The TRIUMPH Corporation

SERVICE BULLETIN

67/8

SUBJECT: Comprehensive Test and Troubleshooting Instructions for all 6 and 12 Volt Battery Ignition Models ("B" & "C" Range from 1963) using Lucas RM19 A.C. Equipment.

SUBJECT: Revised Internal Connections and Test Procedure - 47197 Stator
Fitted as Standard equipment to latest 1967 Triumph models with
Direct A.C. Ignition (no battery) T120/TT, TR6/C, T100/C and T20/M.

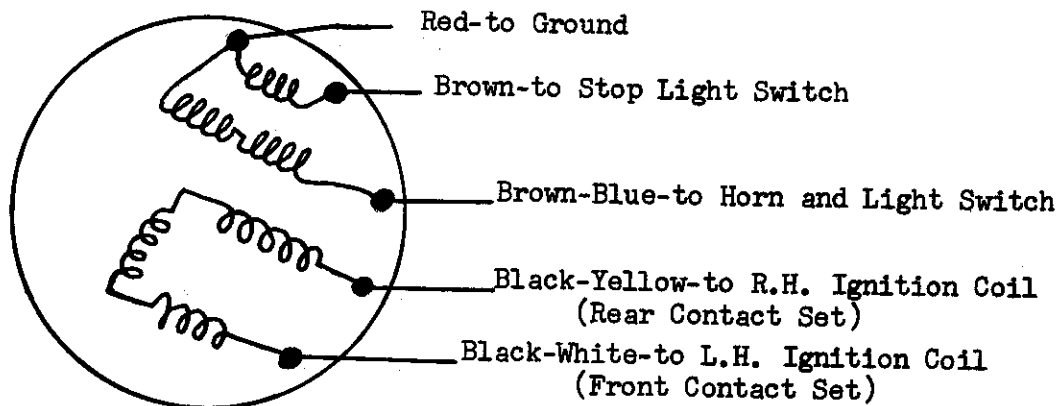
The internal stator connections shown in Fig. H29 (on page H27) apply to
the earlier 47188 stator. The NEW encapsulated stator, part number 47197,
has revised internal connections as shown in the sketch below.

Note that the Brown wire to the stop light is no longer connected to the
ignition windings.

When testing the new encapsulated stator, part number 47197, these output figures
remain the same, but must be obtained by making the following connections:

<u>A.C. Volts (with 1 ohm resistor)</u>
A - Red and Brown/Blue	5.0
B - Black/Yellow and Black/White	2.0
C - Red and Brown	5.0
